State Significant Project - Airly Mine Extension (SSD 12_5581)

Capertee Valley Environmental Group Inc. (CVEG Inc.) objects to the approval of the above mentioned mine extension and jointly with Capertee Valley Alliance (CVA) engaged the Environmental Defenders Office who in turn engaged Experts to review Airly Mine Extension's EIS.

Figure 1-18: Proposed Mining Zones showing Golder's cliff line numbering.

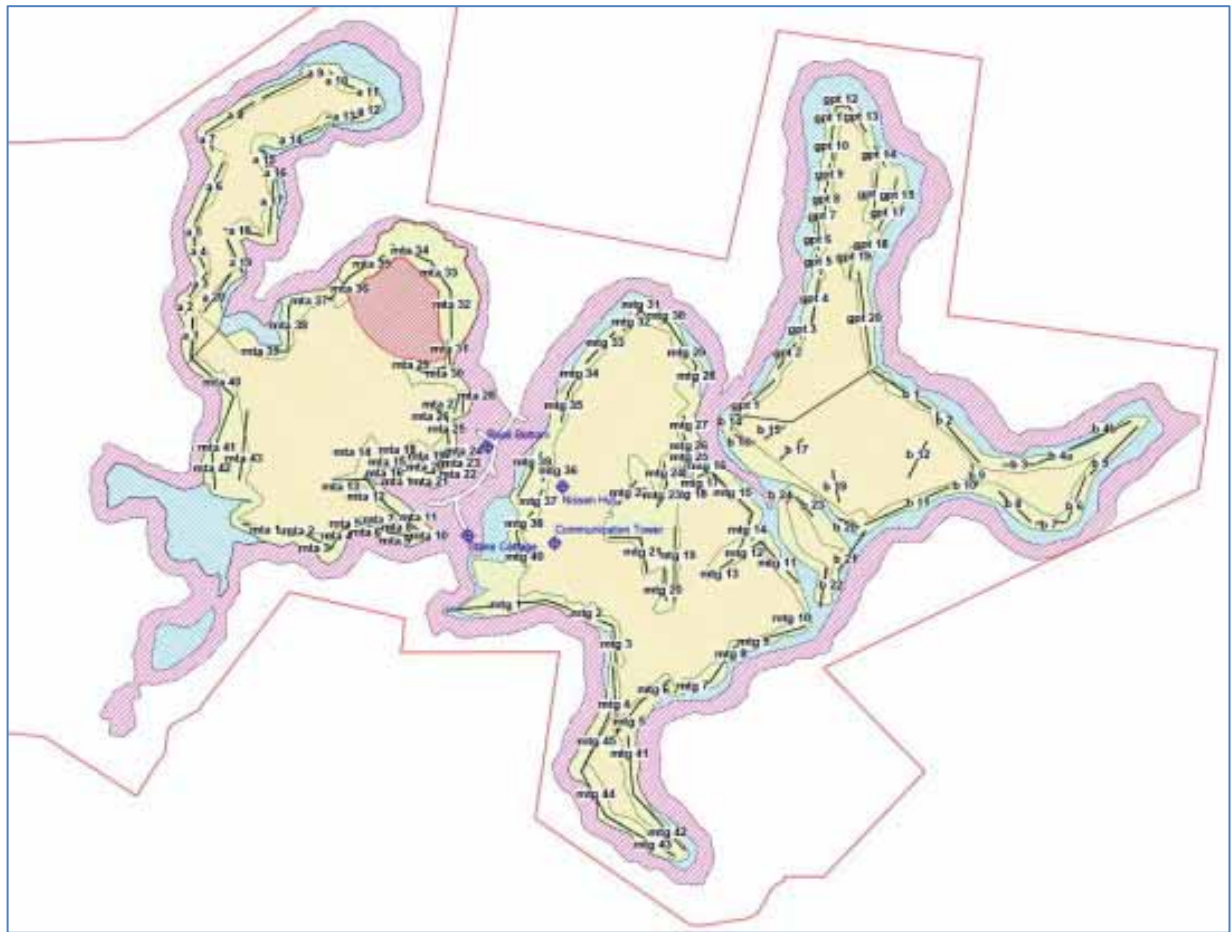
It can be seen from Figure 1-18 that this mining zone constitutes a relatively small proportion of the mine area. Therefore given the uncertainty in respect to the subsidence movements, and the very adverse consequences of cliff line instability, it would appear to be wise and appropriate to eliminate this mining zone. In this case first workings would be adopted from the low cover area through to the plateau area.

Figure 1-20: Environmental Protection Zone superimposed on Mining Zones.

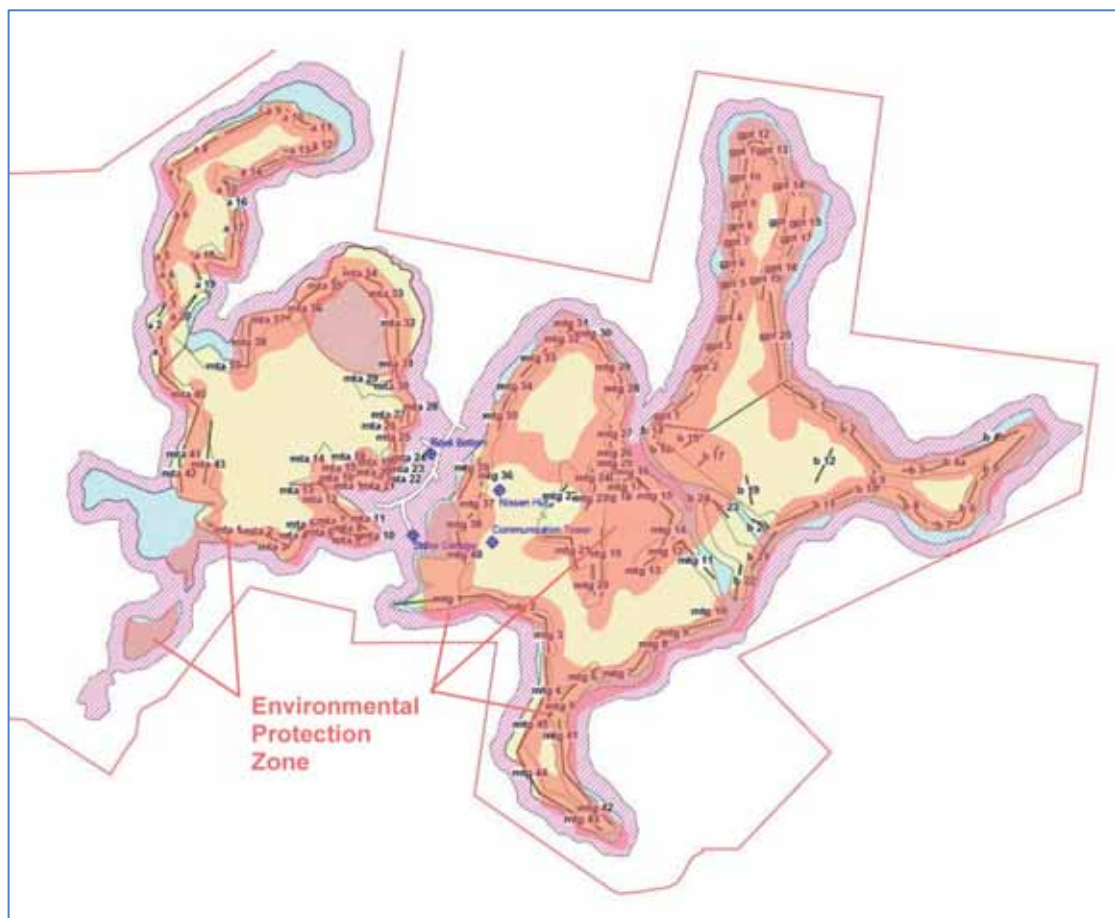
It should be noted that the zones in Figure 1-17 and 1-18 partly overlap with the Environmental Protection Zone shown in Centennial Coal Drg No. 5 of 28 May 2014 (reproduced in Figure 1-19). This is shown in Figure 1-20 where the outline from Figure 1-19 is superimposed on the Mining Zones as given in Figure 1-18. The important point to note is that the Environmental Protection Zone extends well beyond the cliff line zone (Zone 3) described above, which is the zone given particular consideration in the mine plan, designed to limit subsidence so as not to cause cliff line collapses. That is to say that the whole Environmental Protection Zone is not given the level of protection proposed for the 'cliff zone'.

Figure 1-21: Cartoon showing Mining Zones.

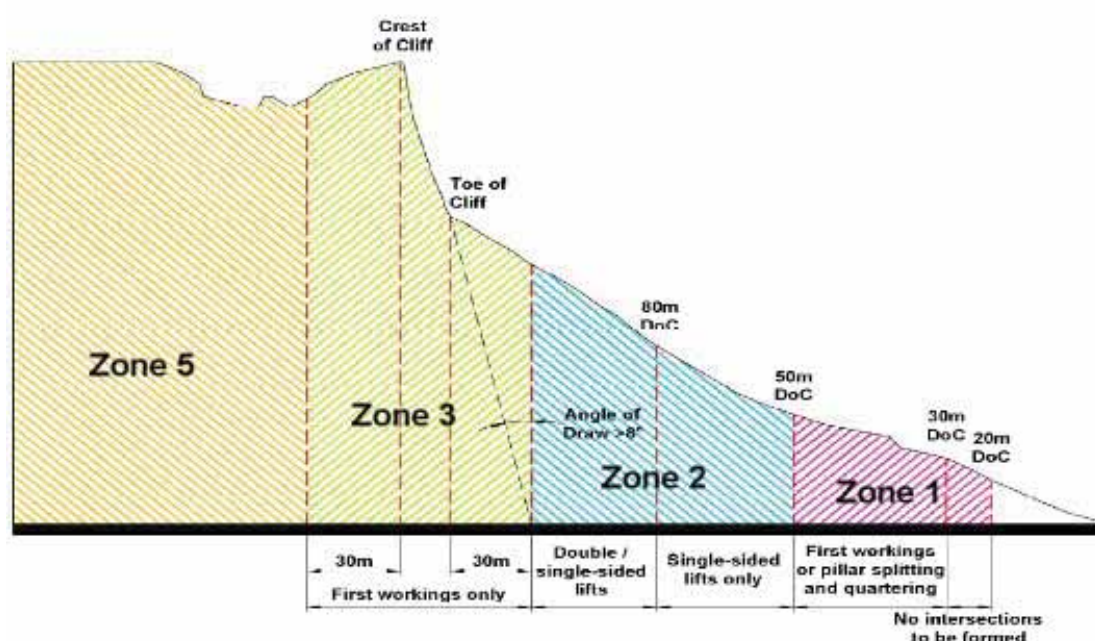
- The Environmental Protection Zone is not given the level of protection proposed for the ‘cliff zone’ (part 1.3)
- Figure 1–21 provided by Pells demonstrates that there might be geometric confusion where the boundary between Zone 2 and 3 is defined both by a distance of 30m from the toe of a cliff line and an angle of >8 degrees, especially where cliff bases are not shown on contour maps (part 1.3)
- There should be a zone 6 which constitutes areas where no mining will take place on Figure 1021A (part 1.3)

Figure 1-21 is a cartoon from Chapter 8 of the EIS that shows how the Mining Zones are related to topography. There could be geometric confusion as per Figure 1-21 where the boundary between Zones 2 and 3 is defined both by a distance of 30m from the toe of a cliff line, and an angle of $>8^\circ$, particularly as the cliff line bases are not shown on contour maps and are difficult to determine. What this means is that the 30m distance and the 8° angle may be in conflict. If as I recommend in Part 2 of this report mining in Zone 2 is restricted to first workings as per Zone 1, then this issue of conflict is irrelevant however with the proposal as set out in the EIS it would be appropriate that the following sentence is included:

The upslope boundary of Zone 2 shall be no closer than 30m from the intersection of the scree slope with the base of the cliff line or no closer than defined by an 8° vertical angle from the intersection of the scree slope with the base of the cliff line, whichever is the greater.

- The estimates of subsidence above the panel (50m wide) and pillar workings (Zone 5 in Figure 1-21) are empirical estimates based on a very limited NSW database⁶, and a numerical model from the USA, and there is substantial uncertainty in respect to subsidence magnitudes (settlement, strain and tilt). There is a significant probability that these magnitudes could be greater than the predicted ranges (settlement 40 to 106mm, tensile strain 0 to 1mm/m). The conclusion documented in Section 1.3, above, that there would be no impacts on the pagoda structures and smaller cliff lines above the panel and pillar mining is based entirely on the assumptions that behaviour will mimic that at Clarence Colliery. However, a paper published in 2014⁷ on Clarence Colliery records that the predicted subsidence range is 20mm to 30mm prior to flooding, with the average maximum above 31 different panels since 2003 being 24mm. Given that the experience at Clarence Colliery is the basis for the Airly Extension mine design, it is my opinion that the panel and pillar design should target the same surface subsidence as at Clarence, namely 20mm to 30mm, and therefore warrants redesign.

- The estimation of subsidence for first workings beneath the cliff lines (Zone 3 in Figure 1-21) are based on elastic theory for stable pillars. I consider this to be appropriate and accept that maximum settlement should be less than about 20mm. However, I am concerned with the conclusion given in Section 6.2.2 of Appendix D that where the workings may fill with water in the long term, settlements could reach about 65mm, with tilts in the range 0.6 to 1mm/m. These tilts mean that a 150m high cliff line could tilt up to 150mm, which is likely to cause joint opening and possible instability. Therefore, in my opinion, the reality is that some cliff line instability must be expected if the areas of first workings fill with water. Therefore, if the intent of the mine plan is to be achieved, namely no mine-induced cliff line instability it will be necessary to ensure that the first

Figure 1-21A: Areas with cover less than 40m in Gap Creek and Genowlan Creek. Note there is a similar area in Airly Creek.

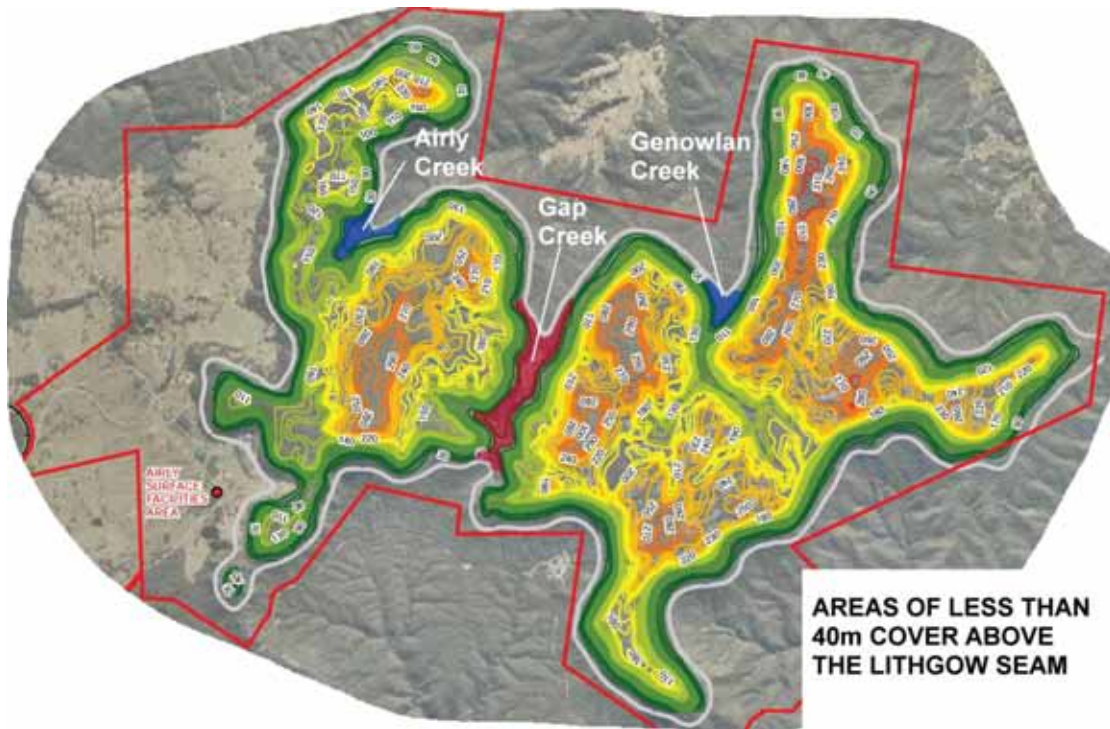
Appendix E does not show the extent of the area covered by the above statement. Therefore, I have used the contour information given in Figure 1-2 to designate these areas, as is shown in Figure 1-21A.

The statement that there will be no mining in the areas shown in Figure 1-21A should constitute a sixth zone to the mine plan. The significance of this is apparent when one considers the mine plan proposed by Centennial Coal in their report of June 2014 (Reference 8). In Figure 1-21B, I have superimposed the “no mining zone” beneath Gap Creek over the mine plan proposed in June 2014. It can be seen that the mine plan of June 2014 is in conflict with the statement quoted above from Appendix E.

Figure 1-21B: Zone of “no mining” as per Appendix E of the EIS superimposed on mine plan submitted by Centennial Coal in June 2014 (Reference 8).

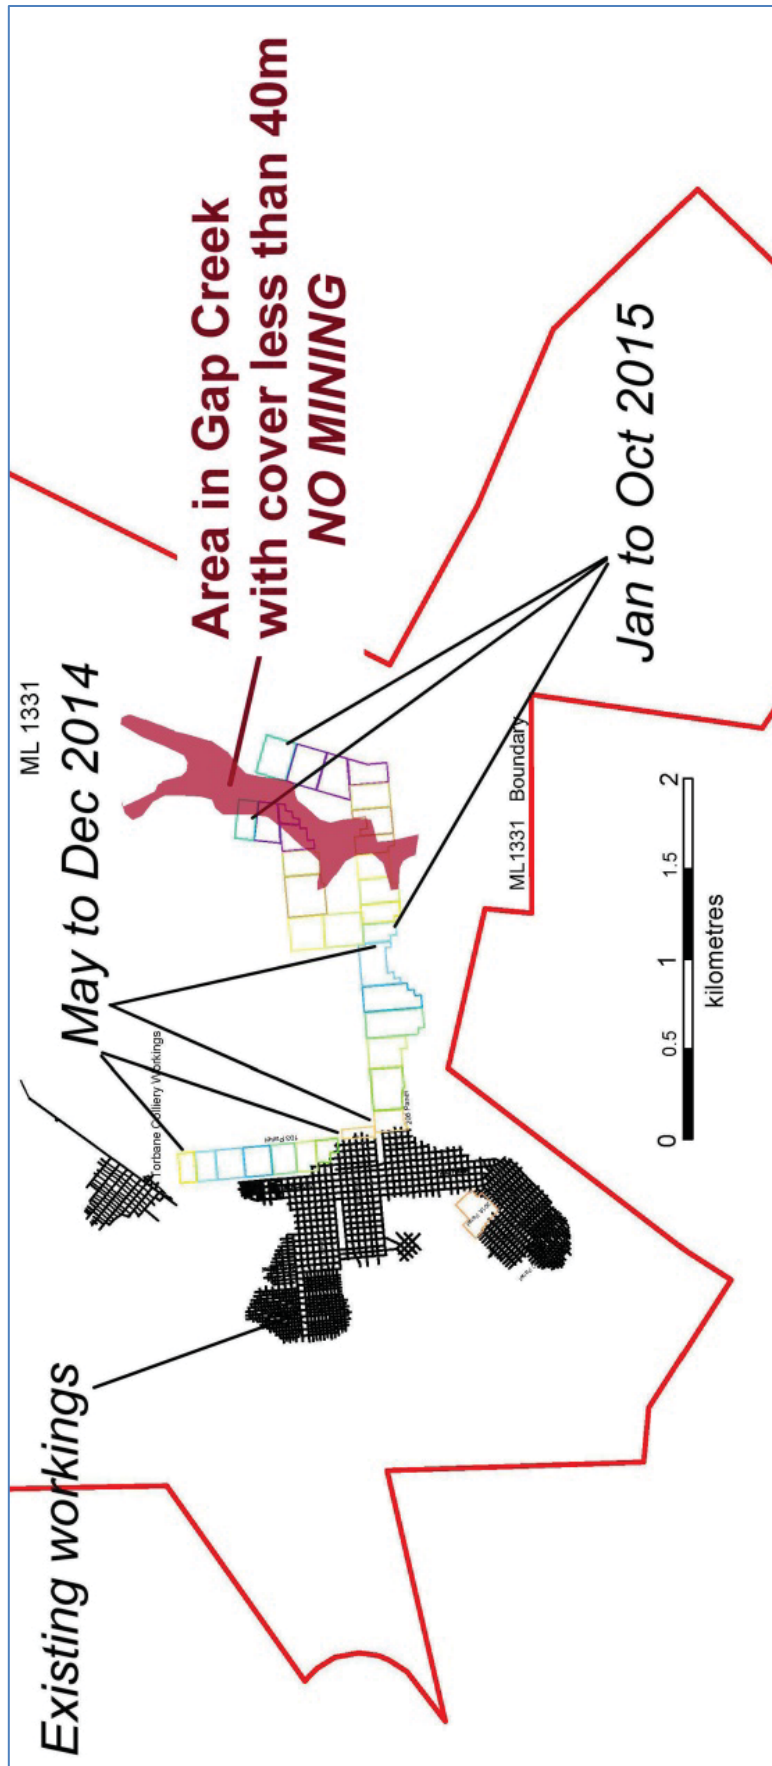
In effect this constitutes Zone 6 to the mine plan which is not dealt with elsewhere in the EIS. According to the writer's interpretation, this constraint of no mining beneath Gap and Genowlan Creeks where the cover is less than 40m, effectively breaks the mining area into a western and eastern part with a major constraint on the connection of these two parts. In addition, this constraint means that the mine plan proposed by Centennial Coal in June 2004 ("Extension of Time") is physically impossible.

- Zone 6: I have drawn attention to the fact that Appendix E of the EIS states there would be no mining beneath Gap Creek and Genowlan Creek where cover is less than 40m. In my opinion, failure to incorporate Zone 6 in the mine planning presented in the EIS is a fundamental issue that warrants re-submission of the EIS.

Figure 1-27: Predicted groundwater inflows into underground workings under proposed conditions.

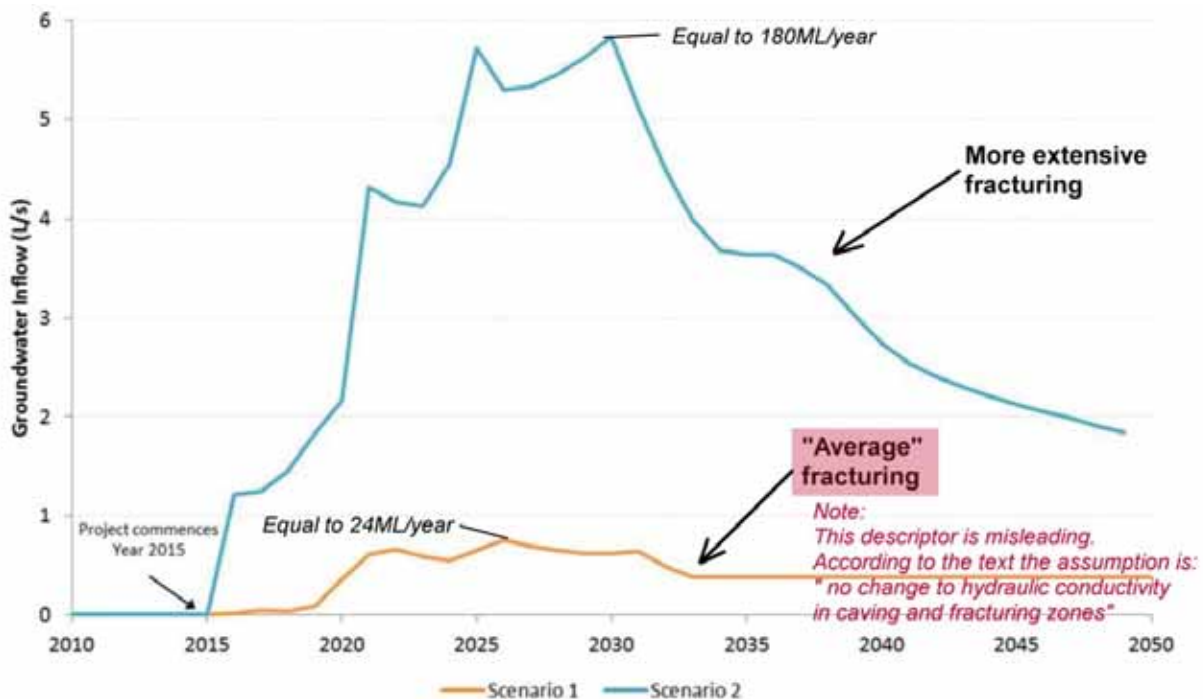
- Access to the processed field test data was requested so that the results could be tested but the information was not provided. (part 1.4.2)
- The report does not present adopted compressibility and volumetric water content parameters in the hydraulic conductivity values for the predictive analyses in Table 2 (part 1.4.3)
- Figure 1–27: the term “average fracturing” is misleading

The comment on Figure 1-27 made by myself should be noted. This is to effect that the wording “average fracturing” which is one the figure in the EIS is somewhat misleading. According to the text of the EIS the assumption is:

“no change to hydraulic conductivity in caving and fracturing zones”.

Figure 2-1: Results from SEEP/W analyses.

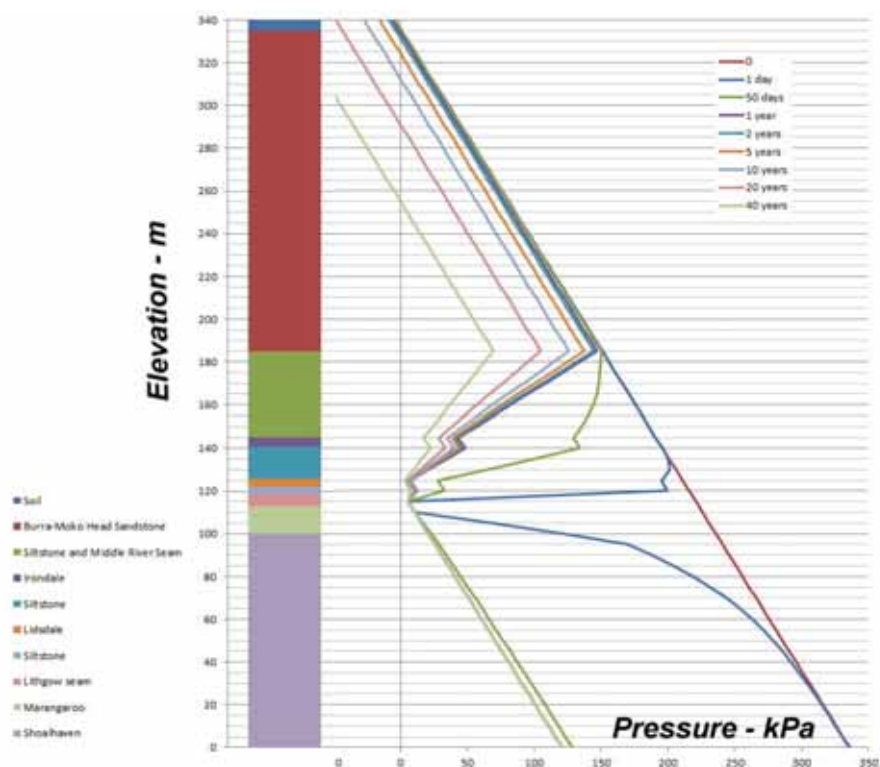
Figure 2-1 shows how the vertical groundwater pressure profile changes with time, in association with dewatering at mine level, using the SEEP/W software. It can be seen that the SEEP/W software shows that depressurisation within the Narrabeen Sandstone (Burra Moko Sandstone) continues with the passage of time. This is the behaviour I expect from first principal of physics.

Figure 2-2: Results from MODFLOW-NWT analyses.

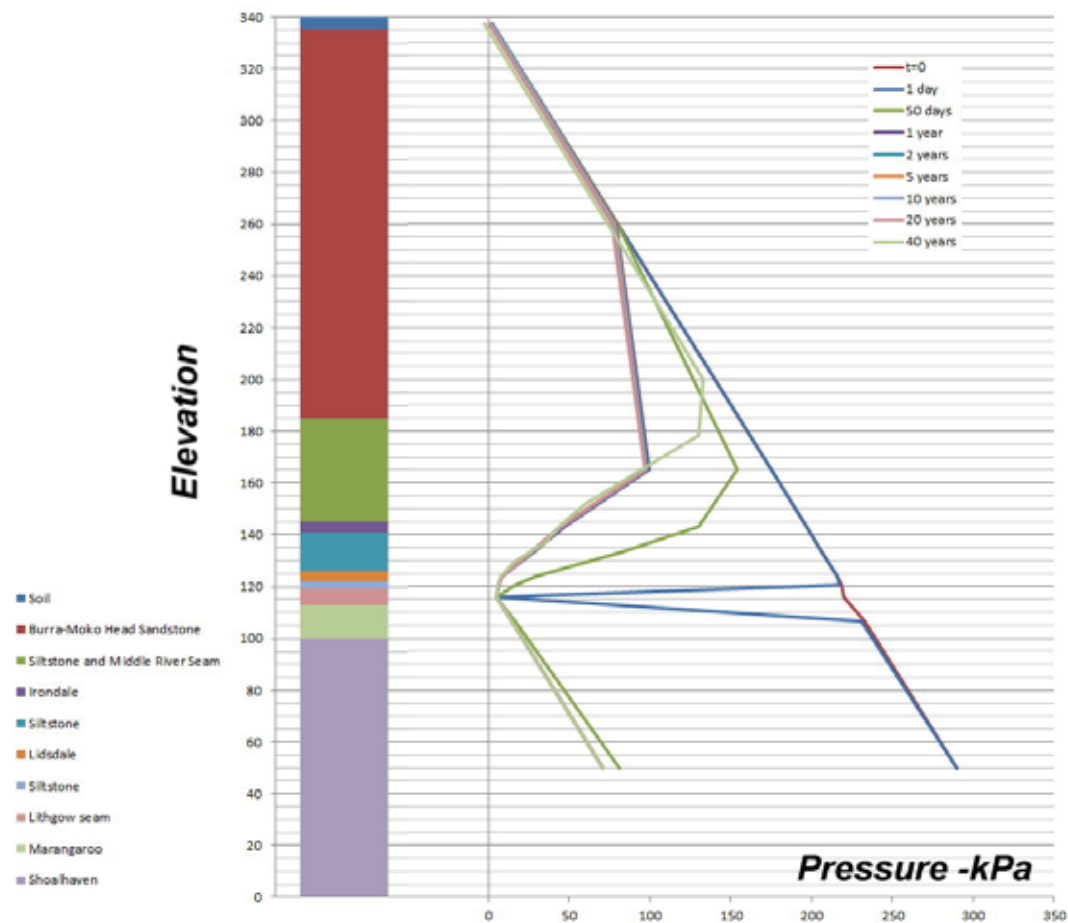
Figure 2-2 shows the same plot but from the MODFLOW-NWT software. The results are similar to the SEEP/W for the initial few months, but after about 1 year computed depressurisation ceases within the Narrabeen Sandstone. This behaviour is inconsistent with fundamental principles, and appears to relate to the software. I have not determined the cause of this unexpected behaviour but it leads me to question a fundamental conclusion of the EIS, namely that there will be no depressurisation in the Burra Moko Sandstone and therefore no impact on springs and seeps that constitute baseflows to the creeks. It is my opinion that this matter warrants resolution by the consultants to Centennial Coal.
